Contract #: 04-0120F4  
 Cty: SF/ALA Rte: 80 PM: 13.2/13.9  
 File #: 69.25B

## QUALITY ASSURANCE -- NON-CONFORMANCE REPORT

**Report No:** NCR-000882

**Reference Description:** Steel backing bars are not continuous for the full length of some welds in Bikepath Assemblies

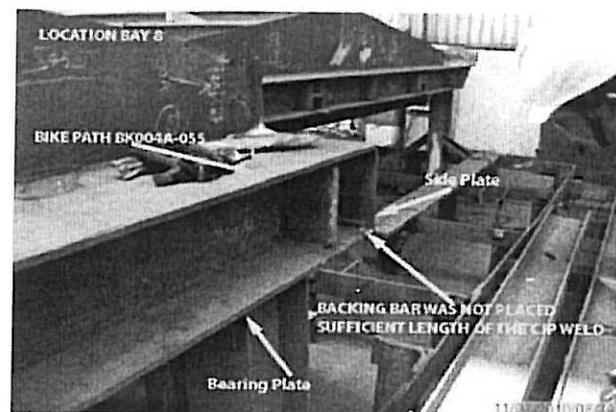
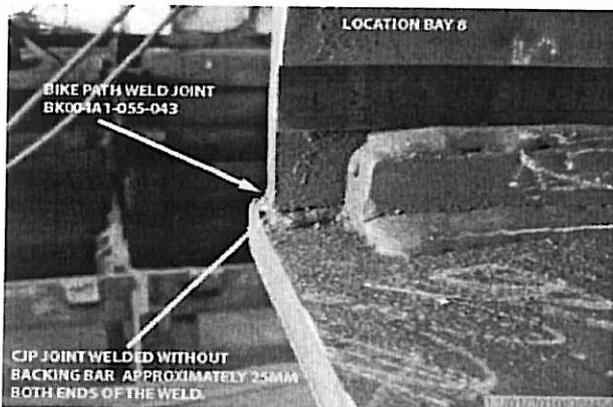
During the Quality Assurance (QA) in process observations of Fabrication of OBG Bike Path BK4A-055, 58, & 61, this QA Inspector discovered the following issue:

- ZPMC welded the root pass of a weld detailed as Complete Joint Penetration (CJP) with backing.
- ZPMC personnel welded the CJP Joint without approximately 25mm of backing at both ends.
- The weld is joining the Bearing Plate and End Plate (side plate) of bike path.
- AWS D1.5 specifies steel backing shall be continuous for the full length of the each weld made with backing.
- The weld is identified as: BK004A1-055-043, BK004A1-058-043 & BK004A1-061-043.
- The material thickness for this backing bar plate is 10 mm.
- This OBG Bike Path is located in Sub assembly Bay #08.

AWS D1.5 2002, Section 3.13.2: "Groove welds made with the use of steel backing shall have the weld metal thoroughly fused with the backing. Steel backing shall be continuous for the full length of each weld made with

Date: 2010-03-26  
File Name: SK-2099R0-1

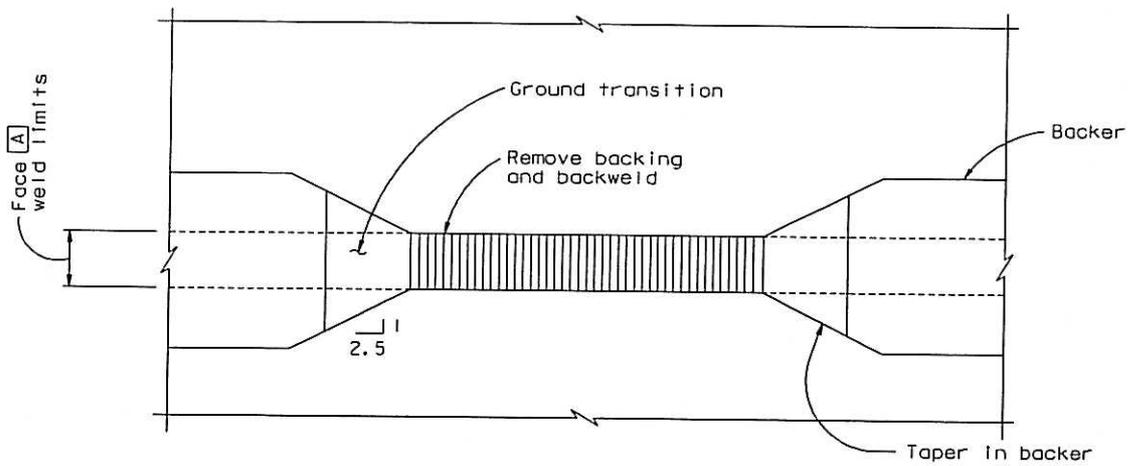
1) The response did not acknowledge the issue of violating the code requirement: AWS D1.5 2002, Section 3.13.2: "Groove welds made with the use of steel backing shall have the weld metal thoroughly fused with the backing. Steel backing shall be continuous for the full length of each weld made with backing."

2) 2 existing RFIs could resolve the issue but none was used. (TC-RFI199R0 backing bar smooth transition requirement; TC-RFI114R0 weld with PJP or keep backing bar full length.)

3) When the backing bar was placed, ZPMC noted that the backing bar was short and had placed it at the middle so that both ends of the weld has no continuous backing. QA Inspector pointed this issue out immediately during fit-up.

ZPMC acknowledges that the backing bar was not continuous for the full length of the weld. In this case ZPMC used the smooth transition outlined in TC-RF1114R0 to rectify this issue, please refer to ABF-NPR-000880R0 where this RFI was referenced as being used to address the issue. The inspector and production team involved have been fined to reinforce the importance of adhering to the code. This particular type of NCR is not prevalent, with the large fine imposed on the inspector and production team, this incident should serve as a example to others and prevent future occurrences?

Contractor propose to repair the backing bar as per per TC-RFI114R0. Contractor will discipline and fine the production team and inspectors involved to reinforce the importance of adhering to the code to prevent future occurrence.

Contractor repaired the welds as per TC-RFI114R0, and provided the documents confirming the welds are acceptable. The involved production team and inspectors were heavily fined, setting an example to others to prevent future occurrences.

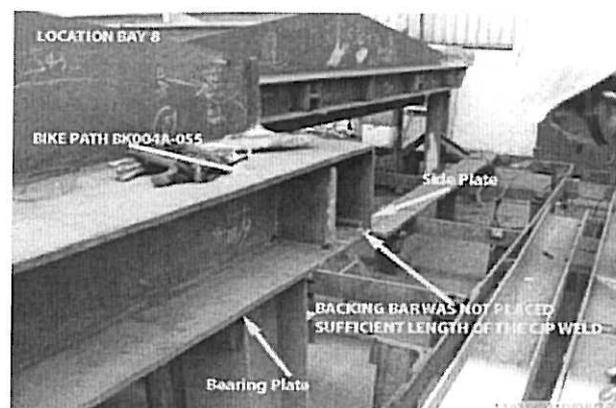
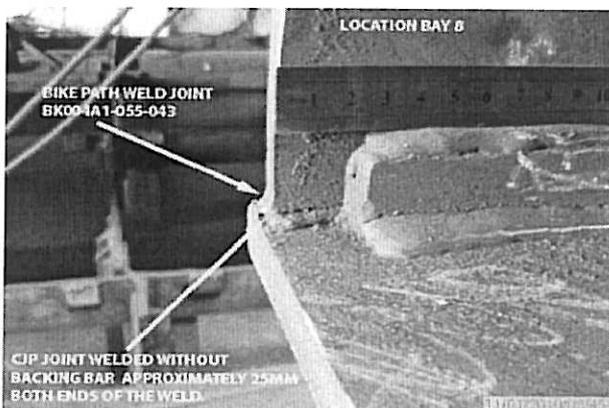
During the Quality Assurance (QA) in process observations of Fabrication of OBG Bike Path BK4A-055, 58, & 61, this QA Inspector discovered the following issue:

- ZPMC welded the root pass of a weld detailed as Complete Joint Penetration (CJP) with backing.
- ZPMC personnel welded the CJP Joint without approximately 25mm of backing at both ends.
- The weld is joining the Bearing Plate and End Plate (side plate) of bike path.
- AWS D1.5 specifies steel backing shall be continuous for the full length of the each weld made with backing.
- The weld is identified as: BK004A1-055-043, BK004A1-058-043 & BK004A1-061-043.
- The material thickness for this backing bar plate is 10 mm.
- This OBG Bike Path is located in Sub assembly Bay #08.

AWS D1.5 2002, Section 3.13.2: "Groove welds made with the use of steel backing shall have the weld metal thoroughly fused with the backing. Steel backing shall be continuous for the full length of each weld made with
